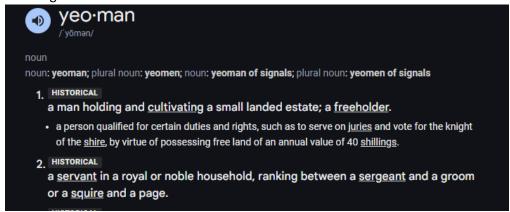
10. Phase 21: 4a – I googled "yeoman" because I had never heard of it... It's a noun not a verb meaning a man:

I don't think its an appropriate or needed term. Just put Subsoil.
